Access Compliance Report Public Rights-of-Way (Curb Ramps)

Main Street: KENNETH_DR Cross Street: WOODLAWN_AVE Location: S

ADA ID: RPRK220107130935 Ramp Type: Type 1 - Perpendicular Diagonal Initial Pass/Fail: Pass Overall Compliance: No Severity Score: 0

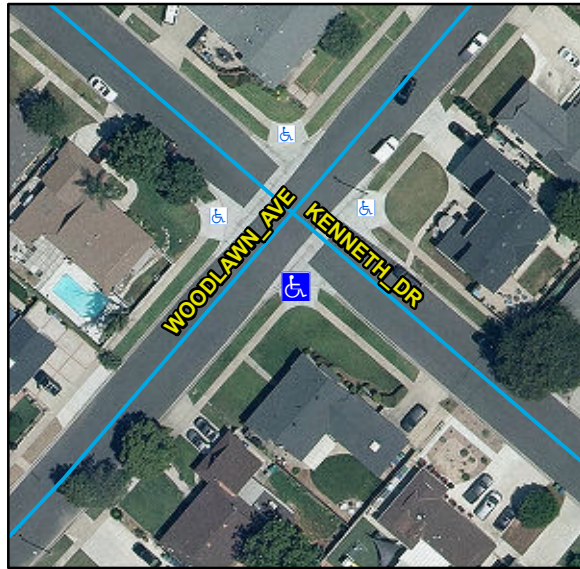
Compliance	Description	Data	Compliance	Description	Data
N/A	Ramp Length (in)	75	N/A	Flare Type LT	
Yes	Ramp Width (in)	48			Sloped
Yes	Ramp Run Slope (%)	6.9	N/A	Flare Slope LT (%)	7.4
Yes	Ramp Cross Slope (%)	1.2	N/A	Flare Traversable LT	No
N/A	Landing Present	Yes	N/A	Flare Type RT	
N/A	Landing Length (in)	49			Sloped
Yes	Landing Width (in)	48	N/A	Flare Slope RT (%)	1.8
Yes	Landing Run Slope (%)	1.5	N/A	Flare Traversable RT	No
Yes	Landing Cross Slope (%)	1.7	Yes	DWS Provided	Yes
N/A	Landing Movement Obstructed?	Yes	Yes	DWS Contrast	Yes
	Landing Movement Type	Curb	Yes	DWS Length (in)	36
N/A	Landing Shared	No	Yes	DWS Full Width	Yes
N/A	Clear Space	Yes	Yes	DWS Offset Left (in)	2
N/A	Clear Space To Crosswalk (in)	48	Yes	DWS Offset Right (in)	N/A
N/A	Marked Crosswalk 1	No	N/A	Marked Crosswalk 2	No
	Crossing 1 Direction	NE		Crossing 2 Direction	NW
	Marked Crosswalk 1 Width (in)	N/A		Marked Crosswalk 2 Width (in)	N/A

Remove & Replace Landing.

R304.2.1, STD 1115
